Access Compliance Report

Public Rights-of-Way

Intersection ID: 12364	Main Street: W_1ST_ST	Cross Street: S_MINT_ST	Location: W
ADA ID: EA2922BDBAC9	Ramp Type: Perp	Initial Pass/Fail: Fail	Overall Compliance: No
		Severity Score: 12.5

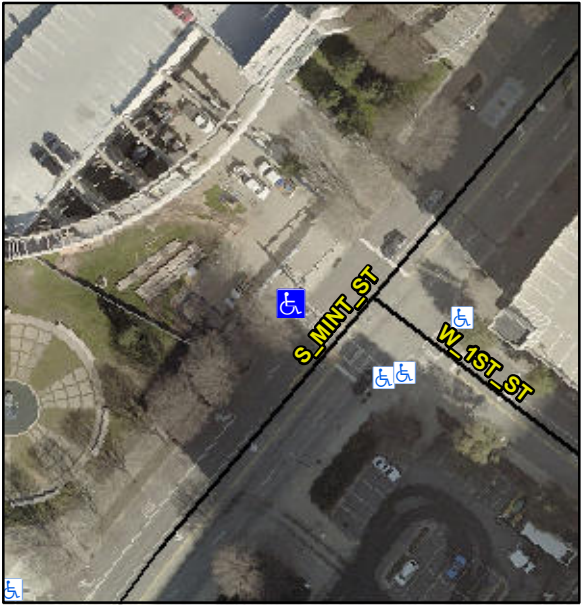
Codes/Mitigation Info/Possible Solution			Field Measurements/Component Compliance		
	Possible Solutions:		Compliance	Description	Data
	Remove & Replace Entire Ramp.		No	Ramp Length (in)	78.0
			Yes	Ramp Width (in)	48.0
			N/A	Flare Type LT	N/A
			N/A	Flare Slope LT (%)	N/A
			N/A	Flare Traversable LT?	N/A
			N/A	Landing Length (in)	N/A
			N/A	Landing Width (in)	N/A
			N/A	Landing Slope (%)	N/A
			N/A	Landing X Slope (%)	N/A
<p>Surveyor Notes:</p> <p>N/A</p> <p>PROW/ADA:</p> <p>Not Found, R304.2.2</p>			N/A	Flare Type RT	N/A
			N/A	Flare Slope RT (%)	N/A
			N/A	Flare Traversable RT?	N/A
			N/A	DWS Provided?	N/A
			N/A	DWS Contrast?	N/A
			N/A	DWS Length (in)	N/A
			N/A	DWS Full Width?	N/A
			N/A	DWS Offset (in)	N/A
			N/A	Shared Landing?	N/A
			N/A	Gutter Ponding?	N/A
			N/A	Gutter Lip Ht (in)	N/A
			N/A	Painted X Walk1?	Yes
				X Walk 1 Direction	To SE
			N/A	X Walk 1 Width (in)	103.0
				X Walk 1 Slope (%)	4.4
				X Walk 1 X Slope (%)	0.0

N/A	Ramp inside XWalk1?	Yes
			N/A	Road Slope (%)	N/A
			N/A	Road X Slope (%)	N/A
			N/A	Any Obstructions?	N/A
				Obstruction Type	
			N/A		
			N/A		
			N/A		
			N/A		
			N/A		
			N/A		
			N/A		
			N/A		
			N/A		
Total Cost:		\$ 1850.00			
			N/A		
			Yes	Surface Condition? (G/P)	Good
